**RIVERDALE CITY PLANNING COMMISSION AGENDA
CIVIC CENTER - 4600 S. WEBER RIVER DR.
TUESDAY, FEBRUARY 24, 2026**

Topic: Burrows Subdivision
RiverPark Retail Final Subdivision/Site Plan Application

On December 19, 2025, Steward Land Company, represented by Jason Thompson from AWA Engineering, petitioned for a commercial Subdivision and Site Plan approval for the RiverPark Retail Subdivision located at approximately 4868 South 1050 West in a Retail/Commercial Park (RCP) zone. The petition seeks to create a 3 lot subdivision by combining an existing parcel (no: 07-819-0002) with a portion of another parcel (no: 07-811-0002). SouthBridge, LLC and FC Riverdale Shopping Center, LLC are the owners of the affected properties. A public hearing is not required to consider this subdivision plat/site plan proposal.

C0.1 Demo

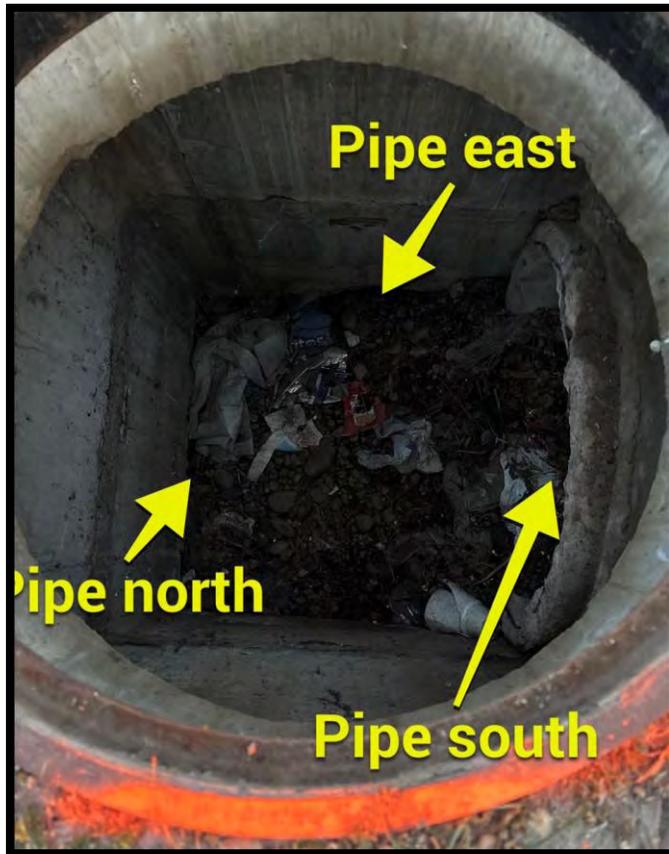
Comment: Label 1050 West/UDOT SR- Street

Response: See revised demo plan.

SHEET NO. **C3.1**

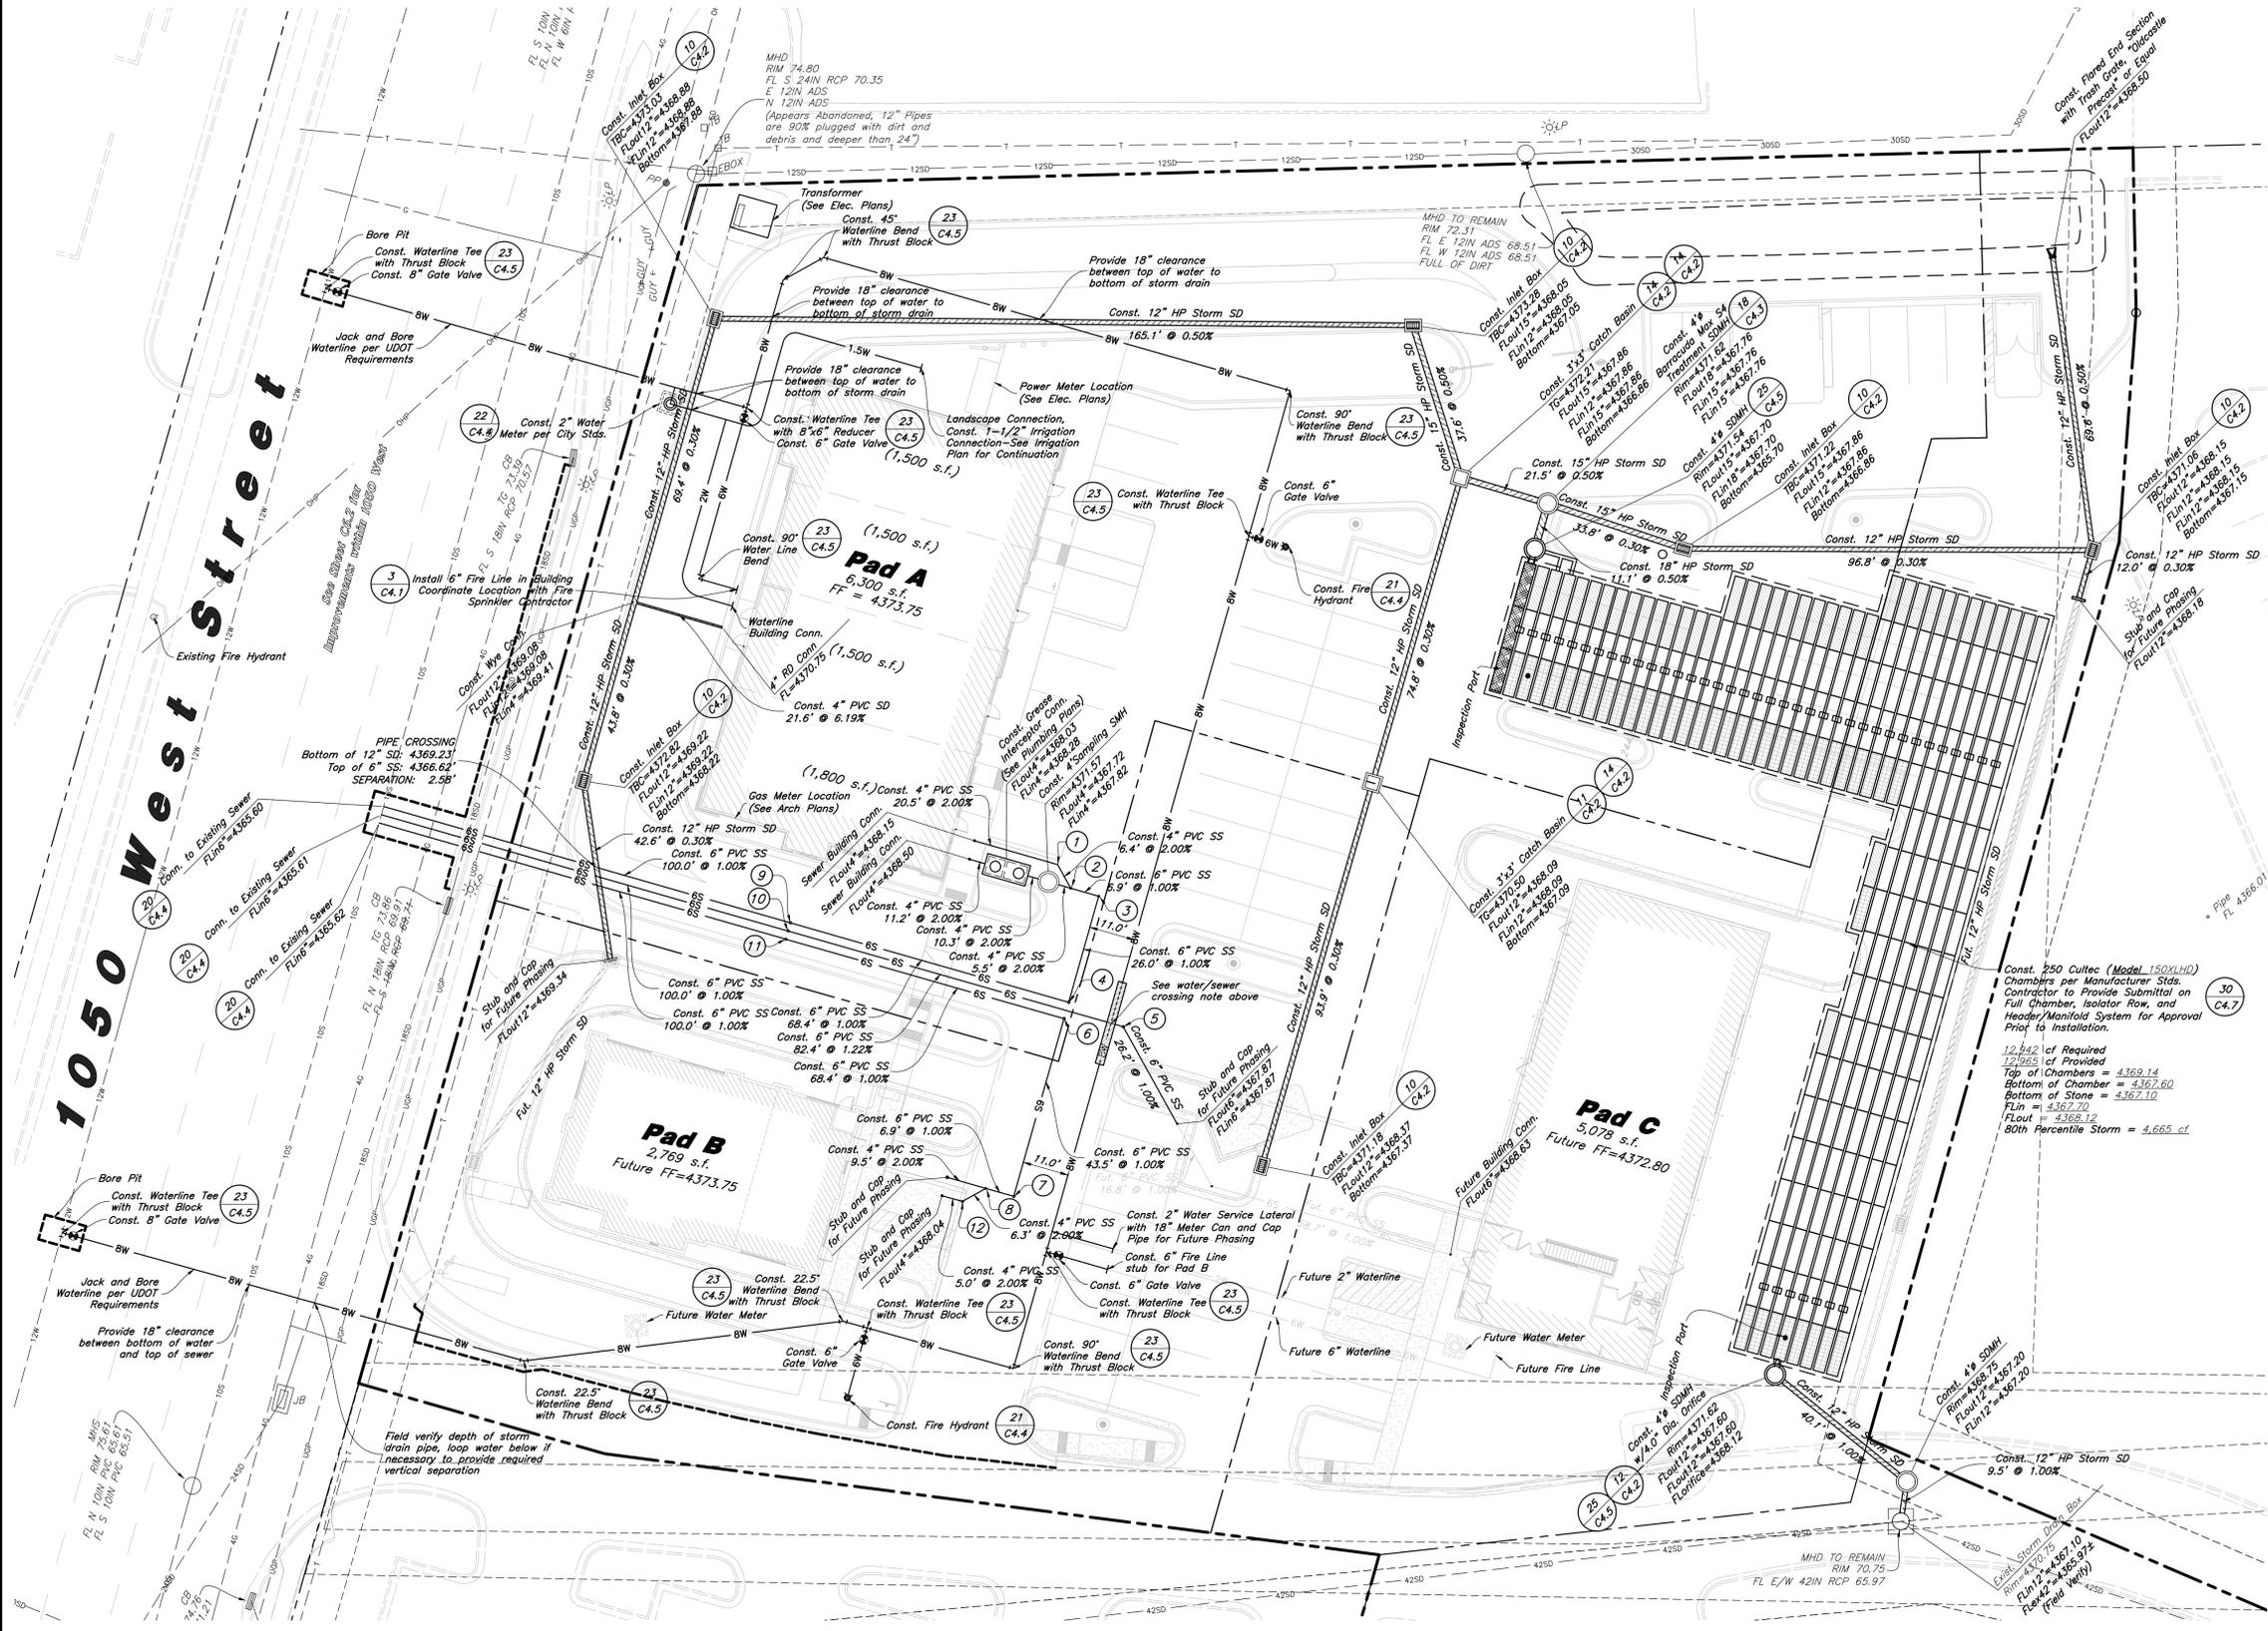
01/12/2026	C3.1 – Utility Plan	Waterline connection to the existing 12” waterline in 1050 West Street shows 6” gate valve and should be 8” gate valve. Need to have thrust block shown behind the existing 12” waterline. Is the plan to cut in a 12”x8” tee with restrained joints?	Not Resolved
		The fire hydrant in the middle island needs to have a 6” gate valve installed/shown. The detail call out needs to be updated from C4.5 to C4.4.	Not Resolved
		I see your detail call outs reference the thrust block detail but not shown on the waterline drawing. Maybe have a call out that all fittings are required to have thrust blocks.	Not Resolved

The existing storm drain manhole/box that is being connected to at the outfall may not be large enough for the 12" rcp pipe to connect. The existing pipes being 42" storm drainpipe coming in and out may not leave enough room if a manhole?	Not Resolved
		The orifice plate is shown on the outfall manhole. What is the elevation for the 80th percentile retention?	Not Resolved
		The fire line to the fire riser room does not show a size. Detail on Sheet C4.1 show a 6" fire line.	Not Resolved
01/12/2026	C4.1 - Details	Detail 3 Fire riser stub in detail shows a 6" fire riser. Make sure they coincide.	Not Resolved
01/12/2026	C4.2 - Details	Detail 10 with the curb inlet does not have a concrete curb behind the inlet frame. Need to have a curb behind to keep box sealed.	Not Resolved
01/12/2026	L2.1 – Irrigation Plan	It appears there is curbing at the northeast corner of the lot but does it cross the property line? There is a line but I'm not sure if it is the property line.	Not Resolved

Comment: The fire hydrant in the middle island needs to have a 6" gate valve installed/shown. The detail call out needs to be updated from C4.5 to C4.4.

Comment: The fire line to the fire riser room does not show a size. Detail on Sheet C4.1 show a 6" fire line.

Comment: Detail 3 Fire riser stub in detail shows a 6" fire riser. Make sure they coincide.

Response: See updated callout on sheet C3.1, Utility Plan

Response: See revised sheet C3.1, Utility Plan

Response: See revised sheet C3.1, Utility Plan

Response: See revised sheet C3.1, Utility Plan.

Response: See revised sheet C3.1, Utility Plan.

Response: See revised sheet C3.1, Utility Plan. A note was added to each fitting and General Utility Note #11 was added.

Response: See revised sheet C3.1, Utility Plan. A manhole was added so the proposed 12" pipe can enter between the existing pipes in the side of the structure. As can be seen in the image below, it is a square/rectangular box. The new 12" pipe will enter the box, perpendicular to the north wall.

Response: See revised sheet C3.1, Utility Plan.

Response: See revised sheet C3.1, Utility Plan.

Curb Inlet with Single Grate

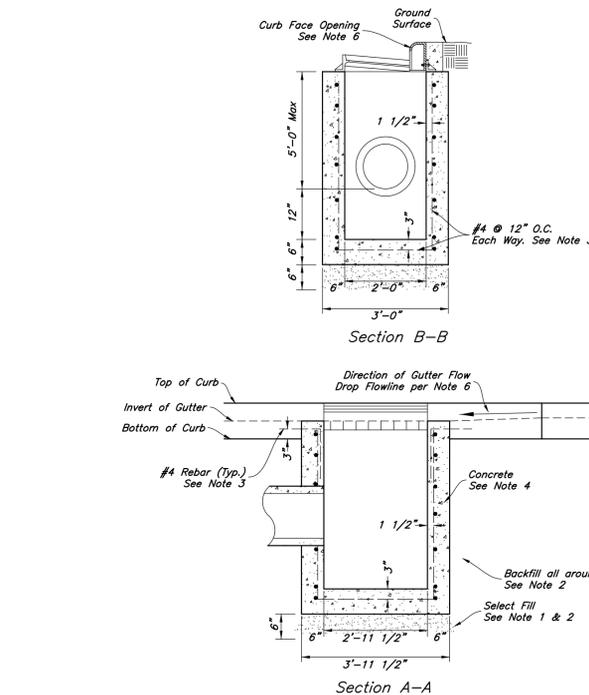
Comment: Detail 10 with the curb inlet does not have a concrete curb behind the inlet frame. Need to have a curb behind to keep box sealed.

5 LANDSCAPE BOULDER
NOT TO SCALE

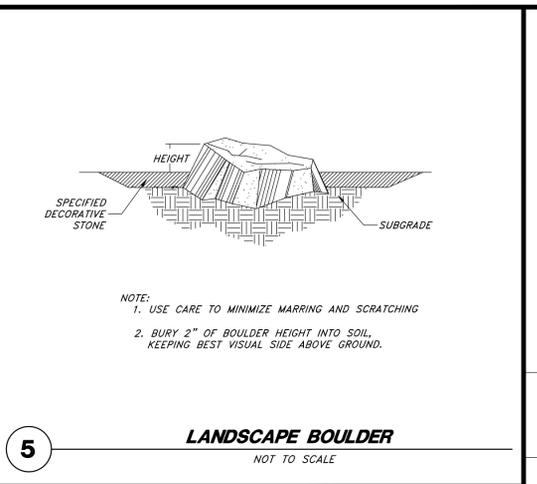
01/12/2026	L3.1 – Irrigation Plan	Detail 5 Landscape Boulder, are there references as to how big these boulders will be? One foot high? Three feet high?	Not Resolved
		Detail 7 Backflow prevention device needs to be a Riverdale City approved device.	Not Resolved

Comment: Detail 5 Landscape Boulder, are there references as to how big these boulders will be? One foot high? Three feet high?

7 BACKFLOW PREVENTION DEVICE
NOT TO SCALE

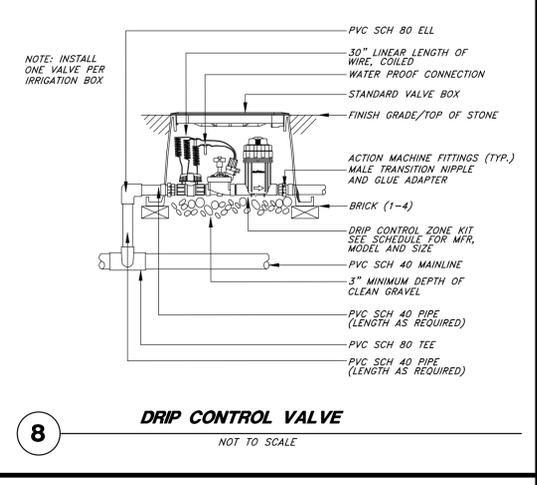
Comment: Detail 7 Backflow prevention device needs to be a Riverdale City approved device.
